SUBDIVISION REVIEW SHEET

CASE NO.: C8-2018-0165.4A

SUBDIVISION NAME: Cascades at Onion Creek East, Phase Four

CITY OF AUSTIN –DEVELOPMENT SERVICES DEPARTMENT
SUBDIVISION APPLICATION – MASTER COMMENT REPORT

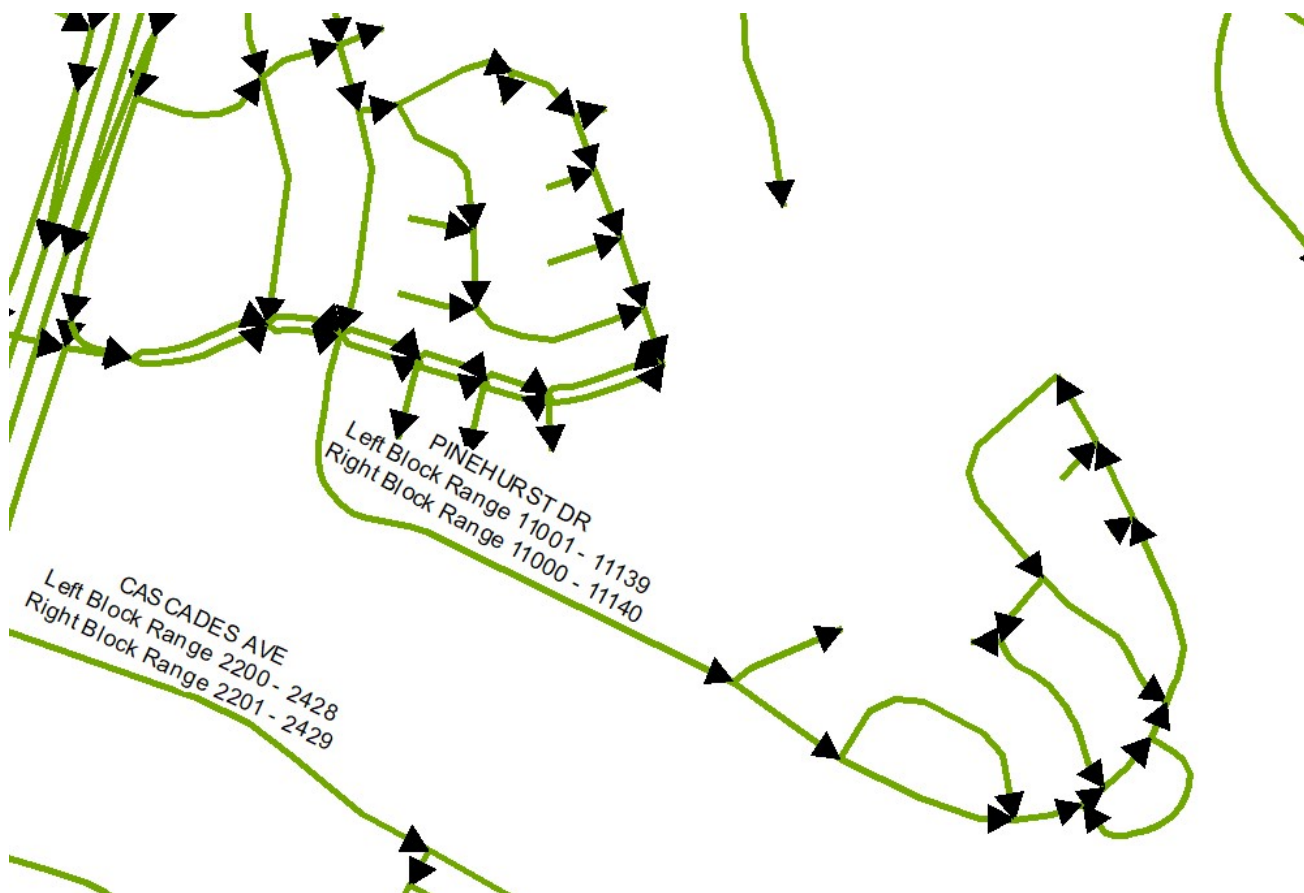
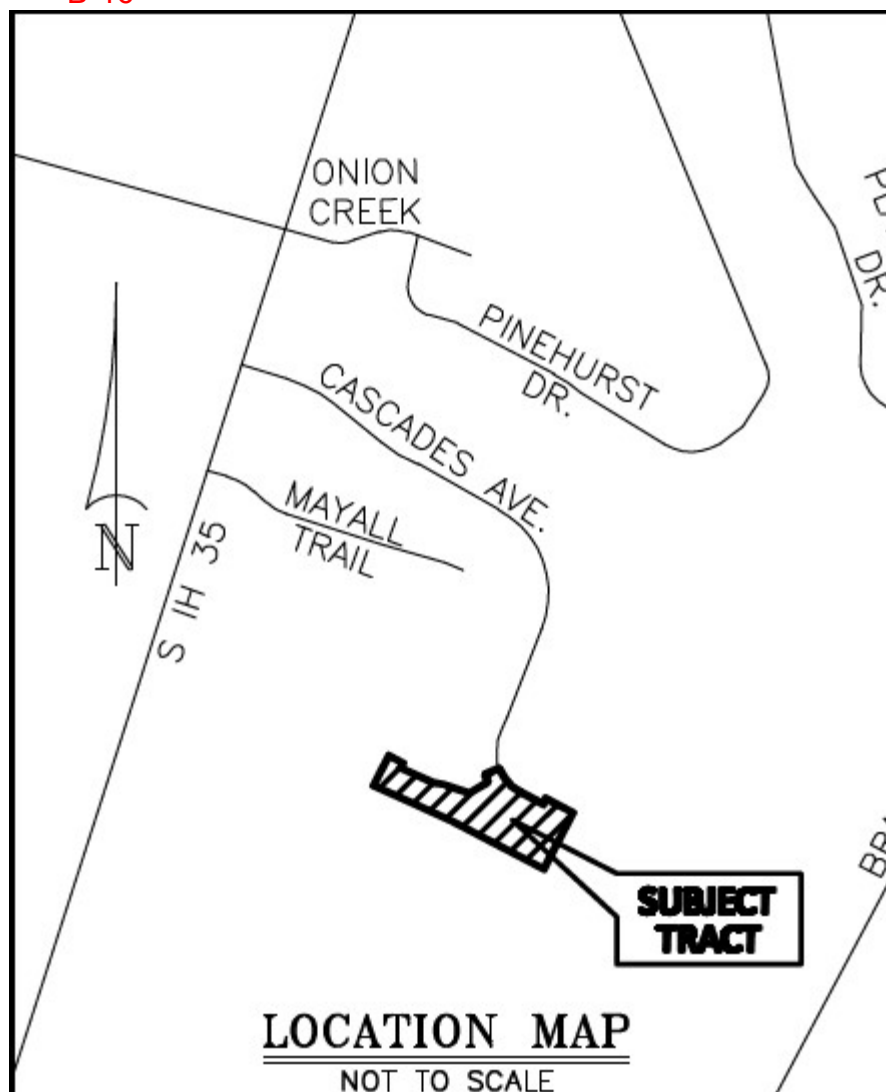
AD4: Please update label to read as follows **ONION CREEK PKWY** in the location map. The street is missing the street type

AD5: PINEHURST DR does not exist north of ONION CREEK PKWY, please correct the linework

PLAT NOTES [LDC 25-1, Article 4]

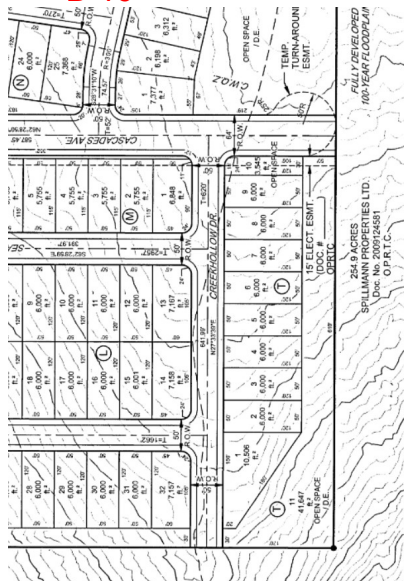
EV 0 Note #23 states: "*Waterway setbacks as defined by the Land Development Code may be located on this property. Development is limited within waterway setbacks.*" [LDC 25-8, Article 7] However, the preliminary plan does not show a CWQZ in the section that is included in this plat. Explain why the CWQZ appears to stop at Cascades Ave. in the preliminary plan (first clip) and is not shown as it is in Property Profile (second clip) and in the ERI (third clip).
